LOCAL DEVELOPMENT PLAN PROVISIONS

PROJECT	LOT 9021 MACNAUGHTON CRESCENT, KINROSS
TITLE	LOTS 20 TO 25 MACNAUGHTON CRESCENT REVISED TO SUIT EXISTING SERVICES
DRAWING NUMBER	2338-SK-002
ISSUE	A

**DRAFT LOCAL DEVELOPMENT PLAN
(MACNAUGHTON CRESCENT STRUCTURE PLAN)
City of Joondalup recommended modifications**

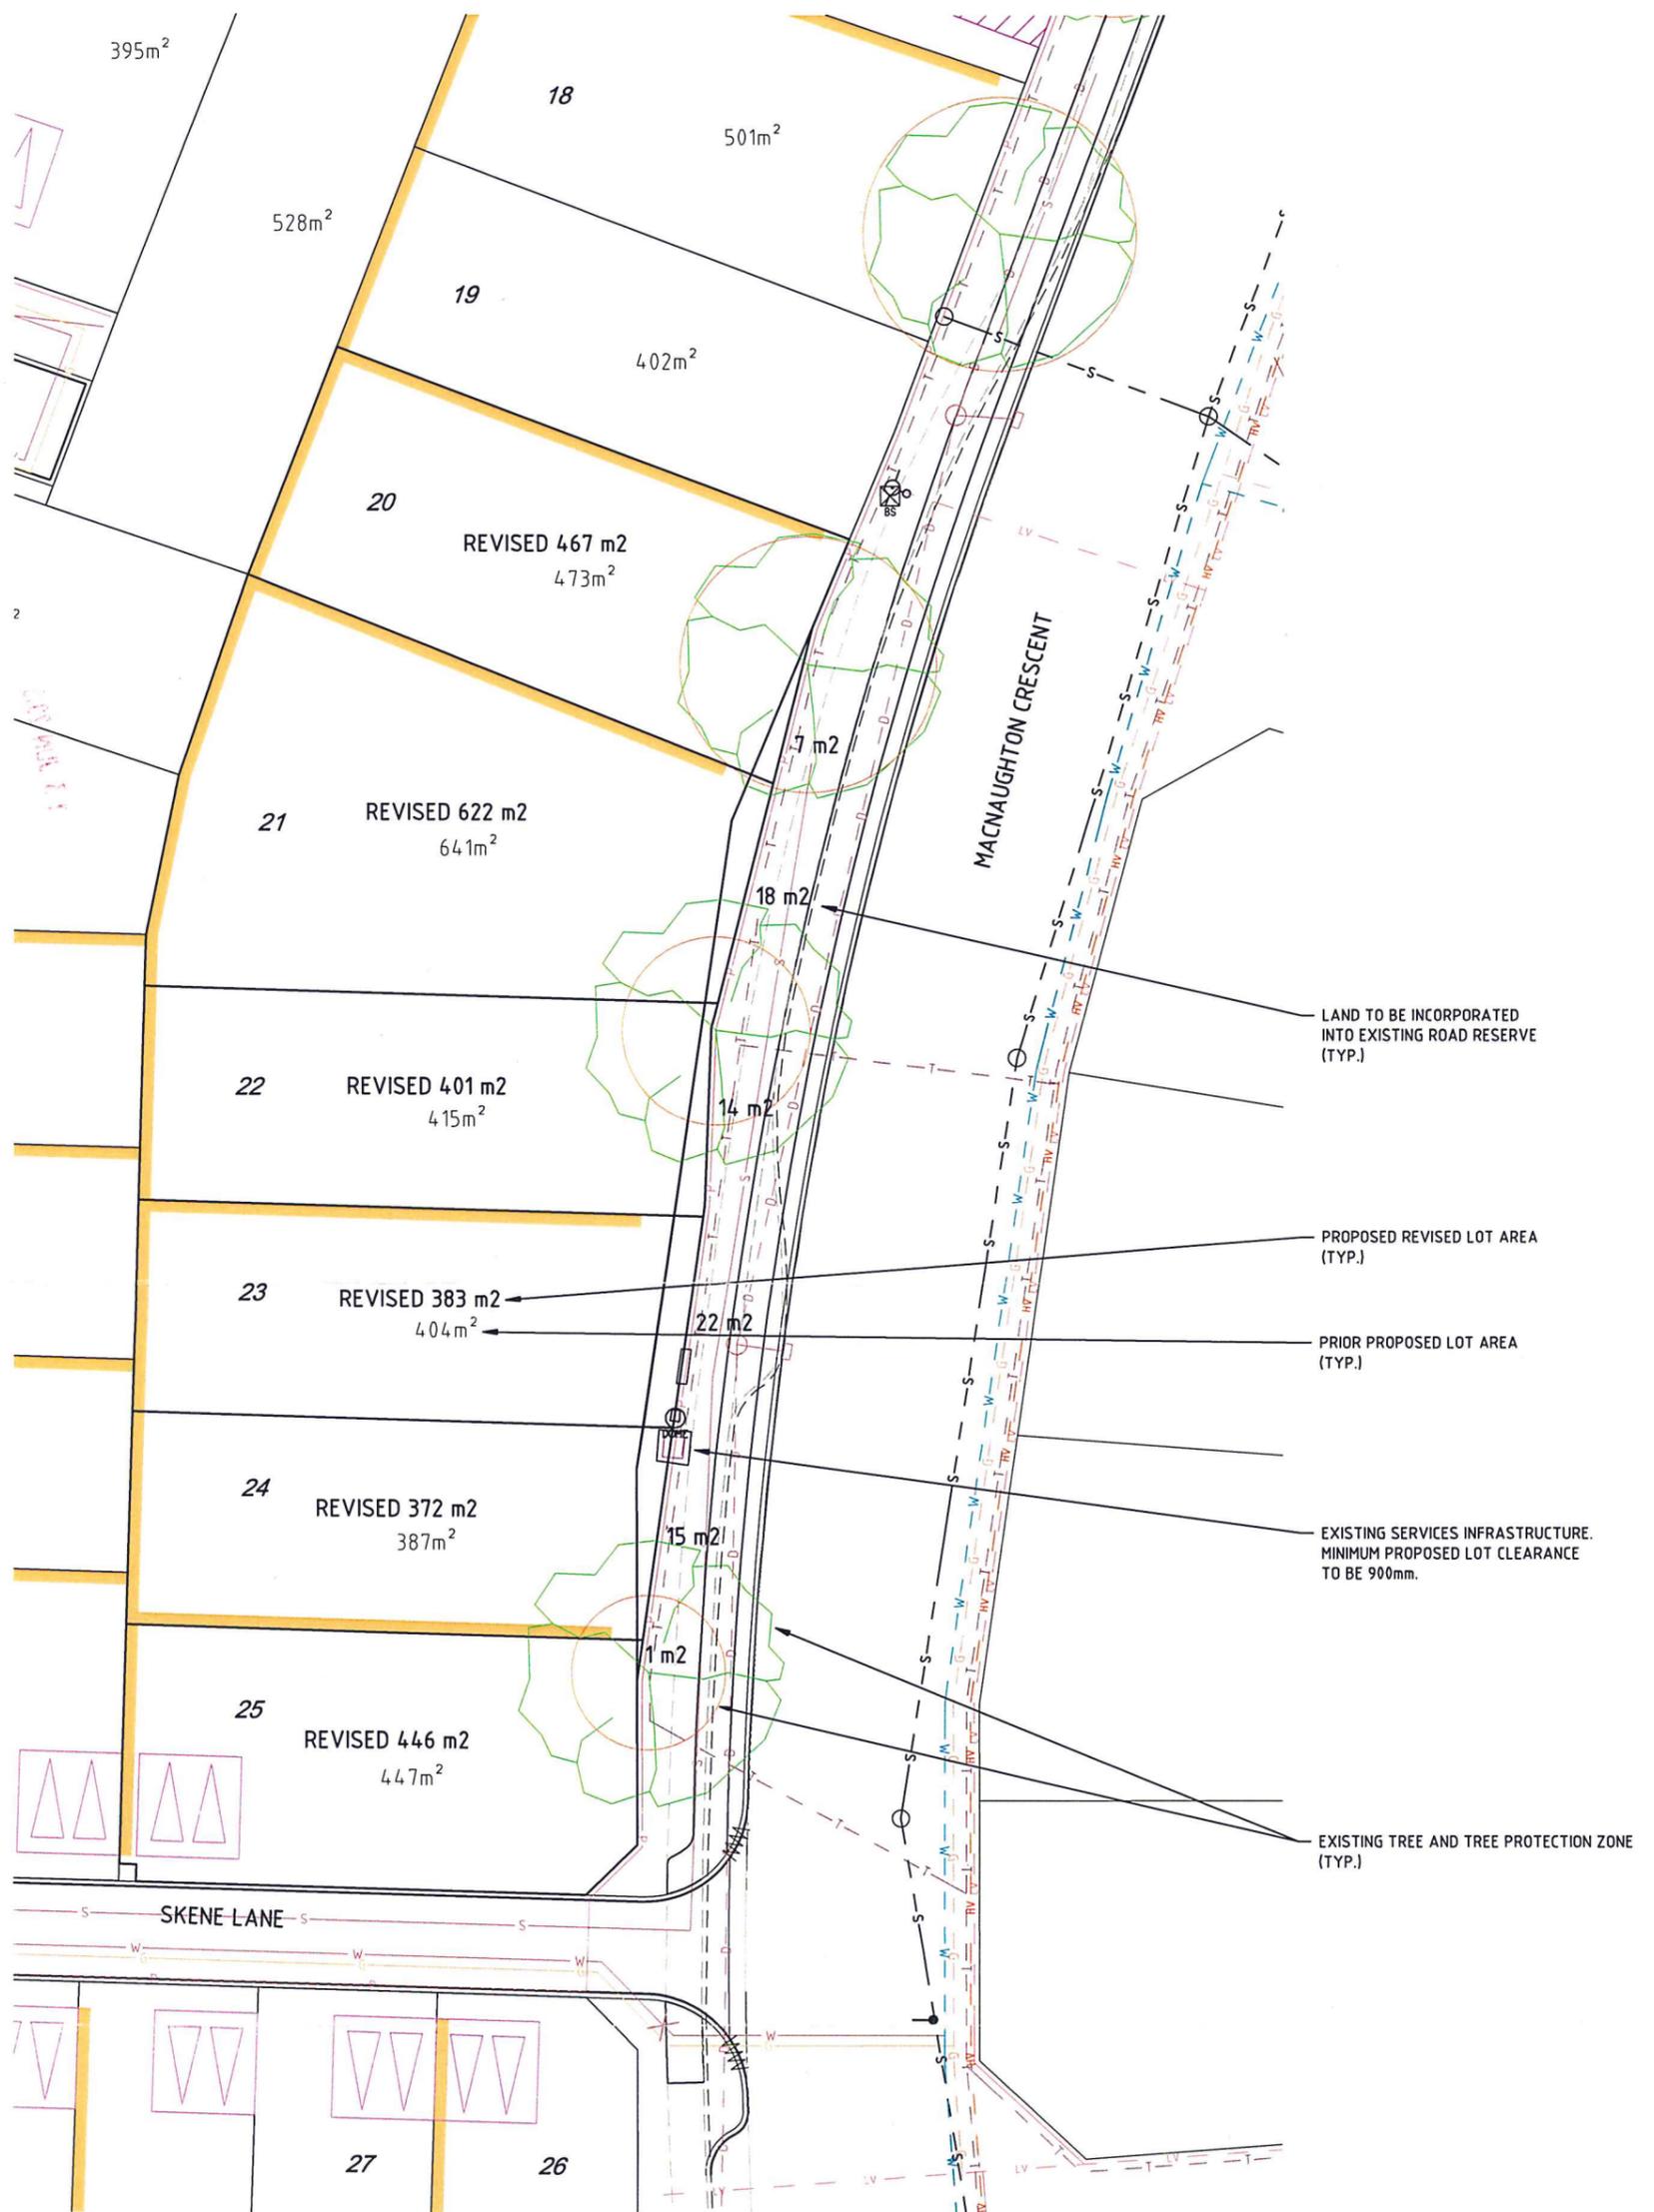
NO.	Provision	Issue	Recommended modifications
	Text to LDP	<ul style="list-style-type: none"> - In the first sentence on page 2, the word “development” does not relate to the WAPC approval. - The terms “City of Joondalup’s <i>District Planning Scheme No. 2 (DPS2)</i>” and “DPS2” do not provide for the imminent coming into effect of the City’s Local Planning Scheme No. 3. - The text appears to quote the description for the R-MD Codes as set out in the State’s Planning Bulletin (Bulletin 112/2016), which is “Medium-density single house development standards – Development Zones (R-MD Codes)” however the City has adopted its own R-MD Policy provisions. 	<ul style="list-style-type: none"> - Delete the word “development” from the first sentence of the text on page 2 of the LDP. - Delete all references to “City of Joondalup’s <i>District Planning Scheme No. 2 (DPS2)</i>” and “DPS2” in the text and replace with the term “local planning scheme”. - Replace the reference to “Medium-Density Single House Development Standards – Development Zones (R-MD Codes)” in the second sentence of the text on page 2 with the “Medium-density Single House Development Standards Local Planning Policy (R-MD Codes)”.

Preamble to the Table	<ul style="list-style-type: none"> - The R-MD reference is as per the Planning Bulletin and not the City’s R-MD Policy. 	<ul style="list-style-type: none"> - Replace the Planning Bulletin title with the “Medium-density Single House Development Standards Local Planning Policy”.
	Table – Building form and orientation	<ul style="list-style-type: none"> - In Column 2 under (a) there are two Roman “i” provisions. 	<ul style="list-style-type: none"> - Replace Roman “i” in Column 2 with “iii”.
	Table - Vehicle access and garages	<ul style="list-style-type: none"> - Inconsistent terminology 	<ul style="list-style-type: none"> - Replace “vehicular” with “vehicle”
